Greater Geelong Planning Scheme Amendment C278ggee

Marshall PSP - Engineering Expert Evidence

Prepared for: Re-Grow C/- Maddocks

29 October 2024

Figure 3: Southern drainage catchment draining to Sparrowvale Wetland

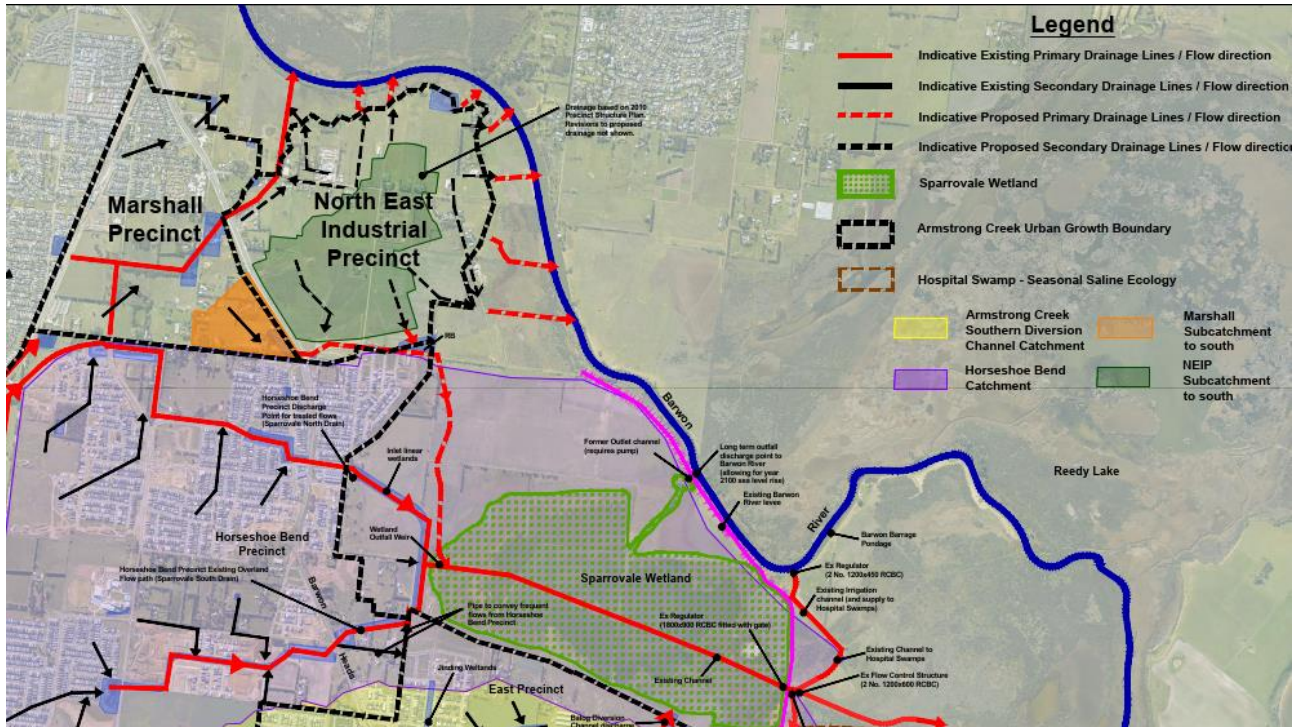
13. The southern Catchment area of the Marshall PSP, and a large proportion of the NEIP is proposed to outfall via Sparrowvale wetlands, and ultimately to Lake Connewarre, as shown in Figure 3 below.

Figure 6: Glenlee housing development and alignment of future 825mm diameter pipe (DI-DR-01a)

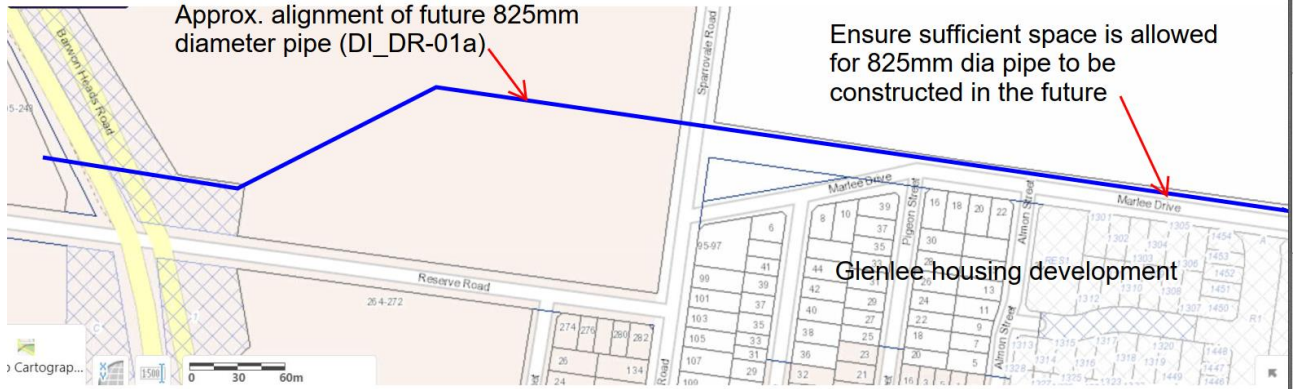
20. I note that the Glenlee housing development is progressing on the South side of Marlee Drive, and that the road and utility service construction works associated with the development will add to the complexity of construction the DI-DR-01a drain in the future. Council should ensure that sufficient road or drainage reserve is provided on the north side of Marlee Drive, in order to provide for the future construction of the proposed 825mm diameter drainage pipe (DI_DR_01a), and also ensure that no utility services are constructed along this drainage alignment. Refer to Figure 6 below which shows the area of concern.
21. This matter should be addressed prior to finalising the Planning Amendment to ensure that the drainage pipe is able to be constructed in the future, and to avoid the construction cost increasing beyond the DCP allowance for the project.

57. Council should ensure that sufficient road or drainage reserve is provided on the north side of Marlee Drive, in order to provide for the future construction of the proposed 825mm diameter drainage pipe (DI_DR_01a), and also ensure that no utility services are constructed along this drainage alignment. This matter should be addressed prior to finalising the Planning Amendment to ensure that the drainage pipe is able to be constructed in the future, and to avoid the construction cost increasing beyond the DCP allowance for the project.

Figure 12: Existing culverts crossing under Barwon Heads Roads – From Spiire concept design plans Appendix 3 of SWMS

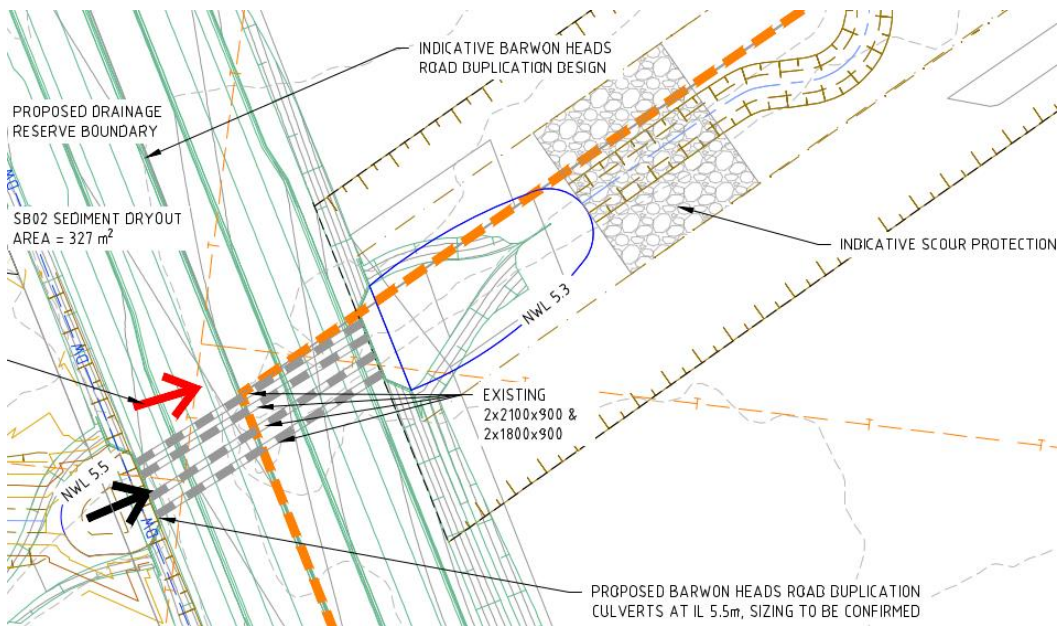
42. The Stormwater Management Strategy (SWMS) prepared by Spiire (2022) indicates that at the upstream end of Tannery Road reach, there are existing culverts under Barwon Heads Road (2 No 2100 x 900mm and 2 No 1800 x 900mm box culverts), as shown in Figure 12 below.

44. With an estimated 1% AEP design flow of 10.2 m³/s for the Tannery Road reach of Marshalls Creek, it would appear that the downstream existing culverts at Tannery Road are undersized.
45. I note that there is a significant difference in the cross sectional areas of the upstream culverts crossing under Barwon Heads Road (7.02m²), compared to the downstream culverts crossing under Tannery Road (3.53m²) – with the cross sectional area at Barwon Heads Road twice the cross sectional area at Tannery Road.

Figure 13: Concept design of Tannery Road reach, showing existing culverts crossing under Tannery Road (From Spiire concept design plans Appendix 3 of SWMS)

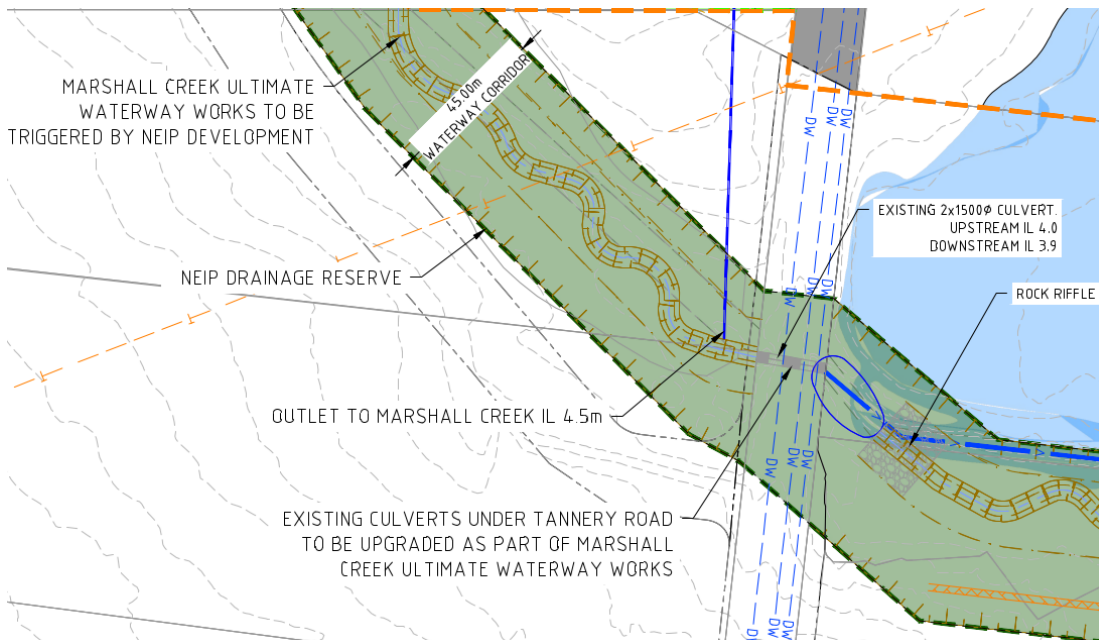
43. The SWMS shows that at the downstream end of the Tannery Road reach, that there are existing culverts under Tannery Road (2 No 1500mm diameter pipes), as shown in Figure 13 below.

46. It is unclear whether there is an intention to upgrade the existing culverts at Tannery Road. There is no mention of upsizing these culverts in the SWMS, except for the note on the concept plan (refer Figure 13 above), which states that the existing culverts are to be upgraded as part of the Marshall Creek ultimate waterway works.

60. The Marshall SWMS should be amended to show the Tannery Road culverts upgraded to cater for the design flows, and the cost allowance in the Marshall DCP (project DI_DR-10) should be updated accordingly. The additional cost for the culverts and reinstatement of the road would likely be in the order of \$250,000.

Figure 16: Extract from Spiire SWMS (Appendix 3 concept plans), with orphaned land highlighted in purple

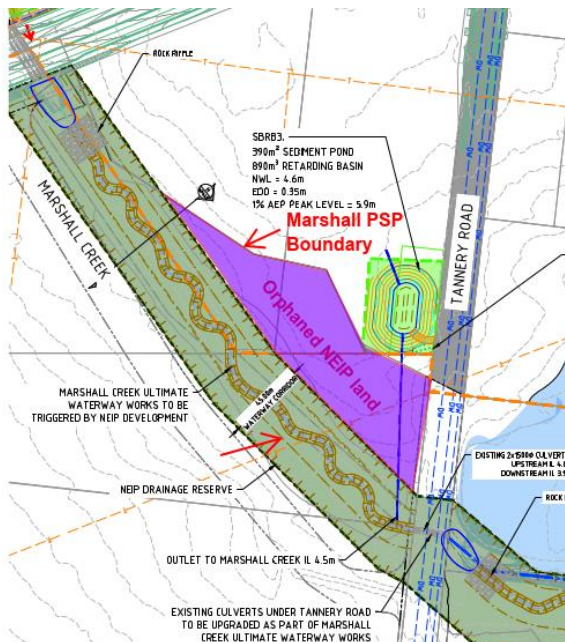
52. Spiire state in the 2022 Marshalls PSP SWMS that Council’s preference is not to have on-line retardation, and hence the retardation basin shown in the NEIP SWMS has been removed from the Marshall PSP. This has resulted in an area of land west of the Marshalls Creek (south of Tannery Road) that is within the NEIP PSP, but disconnected from the balance land within the NEIP PSP, as highlighted purple in Figure 16 below.

Figure 17: Potential realignment of Marshalls Creek Waterway to accommodate Water Quality asset on east side with the NEIP

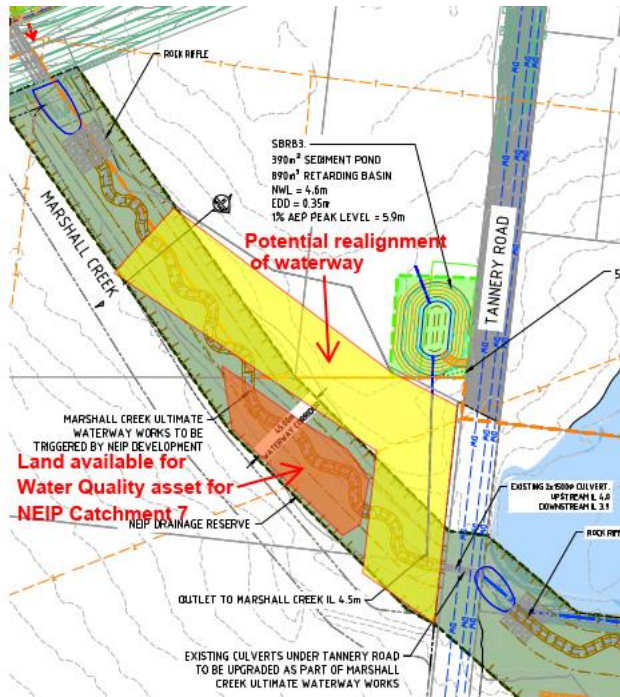
53. Spiire have suggested a possible change to the drainage concept plan that could utilise the orphaned land, by realigning the waterway to the west. This would then result in land being available to provide a water quality treatment device to service the NEIP catchment on the east side of Marshalls Creek, as shown in Figure 17 below.

54. Whilst the Spiire suggestion to realign the creek may have merit, there may be other solutions that make better use of the orphaned land. My recommendation is that the concept plan for Marshalls Creek in the Marshall PSP and SWMS be modified to reduce the area of the NEIP orphaned land, and also that the upgrade of the culverts under Tannery Road be included in the Marshall DCP.

61. The alignment of the Tannery Road reach of Marshall Creek should be adjusted to allow for the future water quality treatment asset in the NEIP, and to fix the issue related to the orphaned land on the west side of the drainage reserve, as shown in Figure 17 on page 23 of this report.
